INSTRUCTION TO SERVICE

ITS:6362

SECTION:	219 Engine and Transmission
WRITTEN BY:	Mike Pearson
SUBJECT:	Rework Heat Exchanger Cabin Loop Line and Routing

Figure 2: Cabin Heat Coolant Tube Removal

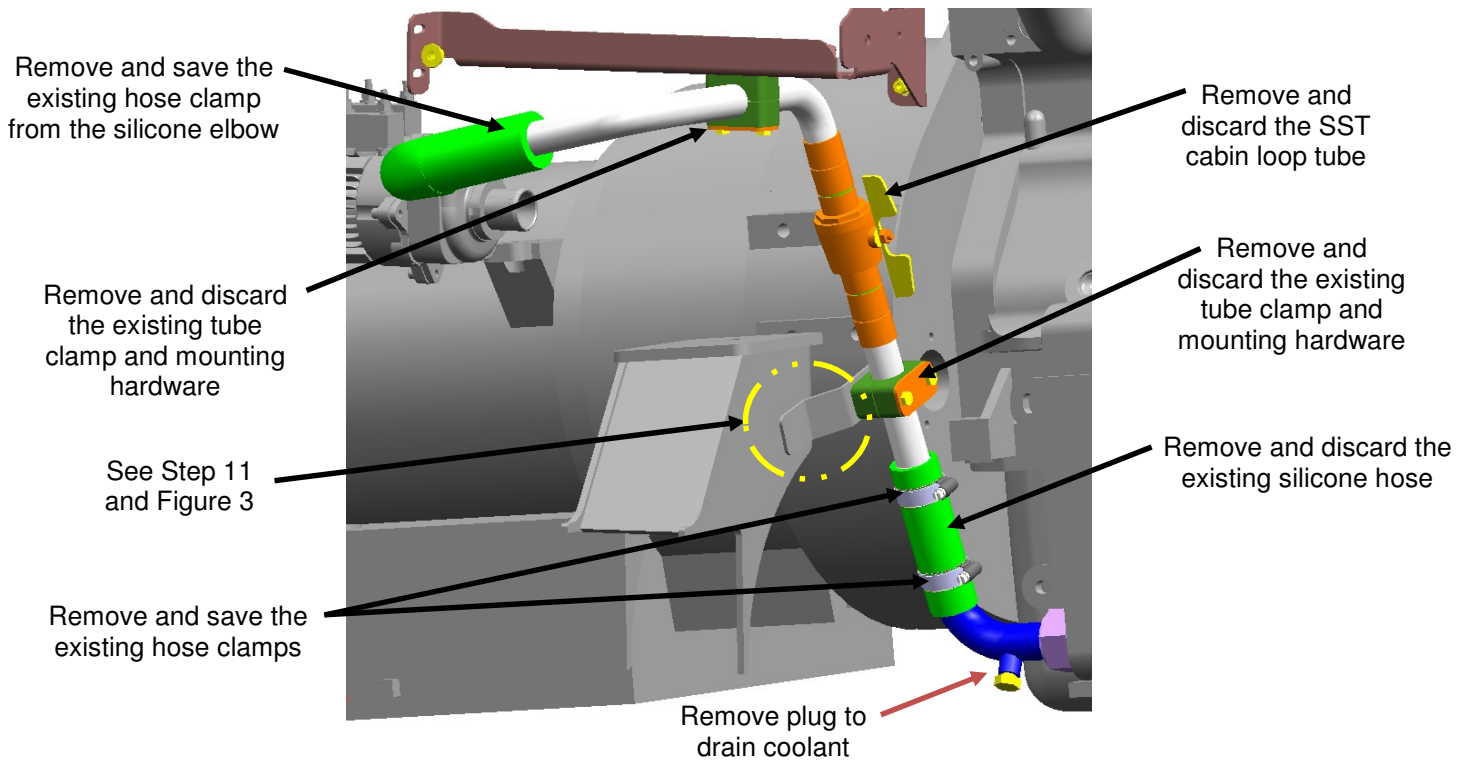
4. Place a suitable container under the heat exchanger cabin loop drain plug. Remove and save the drain plug and drain cabin heat coolant circuit. See Figure 2.

5. If necessary, raise the coach in accordance with the New Flyer Service Manual.
6. Remove and discard the existing tube clamp and mounting hardware supporting the heat exchanger cabin loop SST tube to the de-gas frame as shown in Figure 2.

7. Remove and discard the existing tube clamp and mounting hardware supporting the heat exchanger cabin loop SST tube to the clamp mounting bracket (bracket may vary in appearance) as shown in Figure 2 and 3.

8. Remove and save the existing hose clamp from the silicone elbow on the booster pump line to the SST cabin loop tube, see Figure 2.
9. Remove and save the existing hose clamps from the silicone hose connecting the heat exchanger 90° SST elbow to the SST tube to the booster pump, see Figure 2.

10. Remove and discard the existing silicone hose and SST cabin loop tube, see Figure 2.

Figure 3: Booster Pump Supply Line Clamp Support Bracket Removal

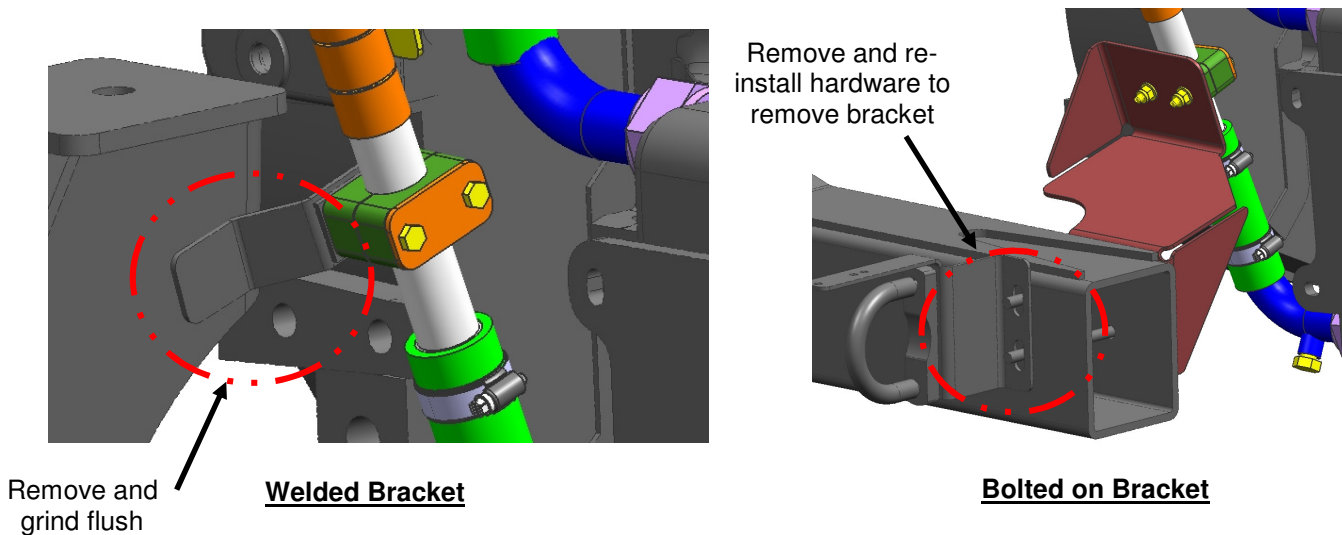
11. The cabin heat coolant tube support clamp mounting bracket may vary in appearance;
- If the existing support bracket is welded to structure, grind off the bracket flush with frame and apply zinc primer to the exposed metal left by the grinding process to prevent corrosion, see Figure 3.
 - If the existing support bracket is bolted to the frame, remove the bolts from the forward lower radiator tube mounting bracket, remove and discard existing coolant tube bracket and re-install the lower radiator tube mounting bracket bolts. Torque bolt (x2) to 40-70 in*lbs dry, see Figure 3.

Figure 4: Tube Assembly Installation

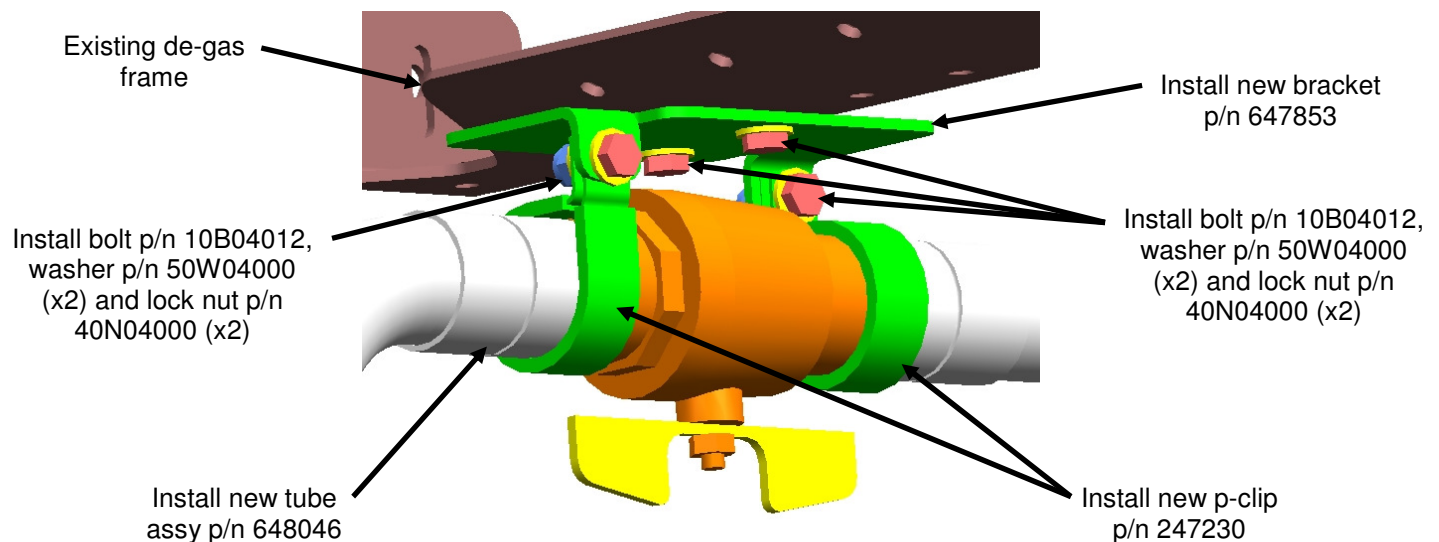
12. Using the same mounting holes as the removed tube clamp from Step 6 install the new tube support bracket p/n 647853 to the de-gas support bracket using new bolts p/n 10B04012 (x2), washers p/n 50W04000 (x4) and lock nuts p/n 40N04000 (x2), torque hardware to 12 ft*lbs dry. See Figure 4.
13. Loosely install the new tube assy p/n 648046 to the newly installed bracket from Step 12 using p-clips p/n 247230 (x2), washer p/n 50W04000 (x4) and lock nuts p/n 40N04000 (x2). See Figure 4.
14. When installing the new tube assy to the newly installed bracket, the end to the booster pump is to be loosely installed into the existing silicone elbow at the pump using existing clamp from Step 8. If existing silicone elbow is worn or does not fit correctly to the new tube assy it should be replaced with a new elbow p/n 606473. New elbow it to be trimmed to fit.

Figure 3: Cabin Heat Coolant Tube Installation

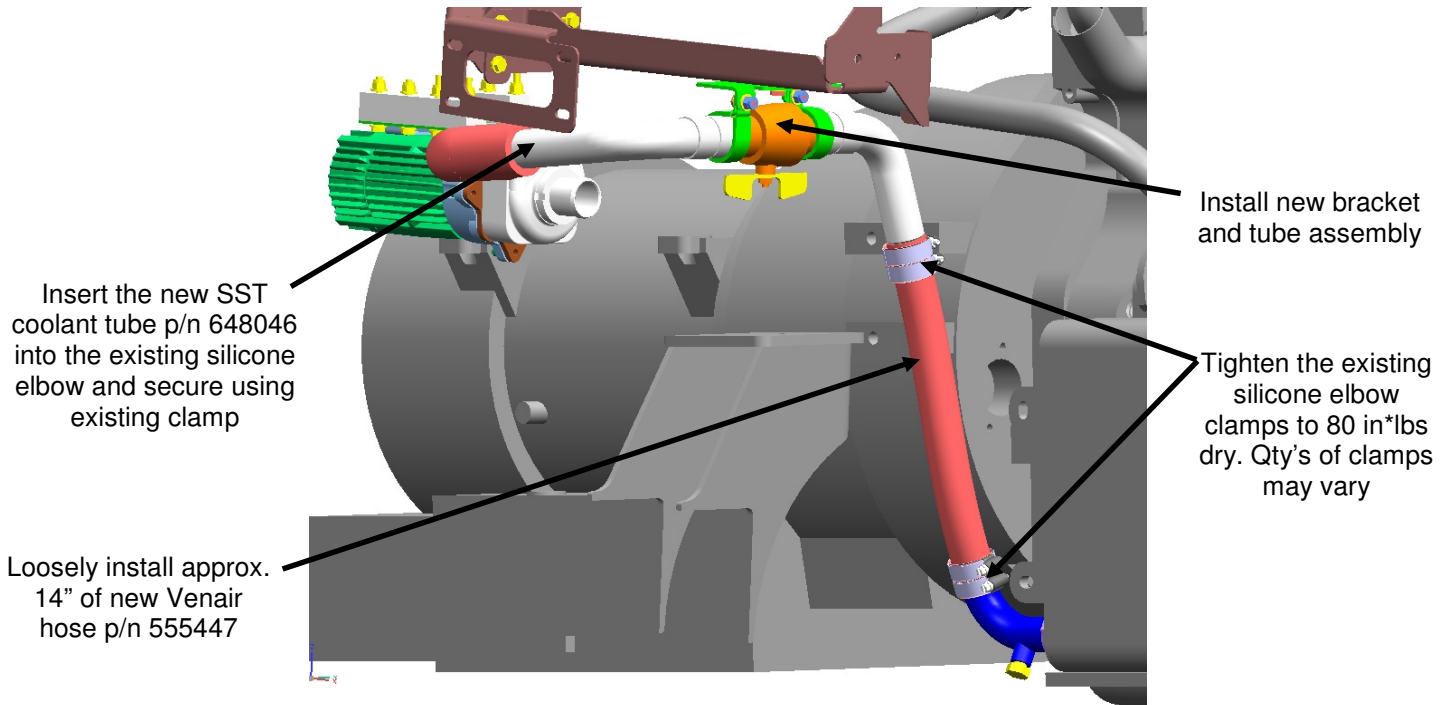
15. Loosely install approx. 14" of new Venair hose p/n 555447 (trim hose to fit) between existing heat exchanger cabin heat SST elbow and newly installed tube assy from Step 13 using existing hose clamps removed in Steps 8 and 9, qty's of clamps may vary depending on the install.

16. Ensure the silicone hose, silicone elbow and tube assy are free of kinks and the routed in a relaxed state and tighten clamps as follows.
 - a. Tighten existing tube assy p-clip hardware installed in Step 13 to 12 ft*lbs dry.

- b. Tighten the existing silicone elbow clamp from Step 14 to 80 in*lbs. Dry. Tighten at 75 rpm or less, re-torque to 80 in*lbs. at 75 rpm or less after 30 mins.

- c. Tighten the existing silicone hose clamps from Step 15 to 80 in*lbs. Dry. Tighten at 75 rpm or less, re-torque to 80 in*lbs. at 75 rpm or less after 30 mins.
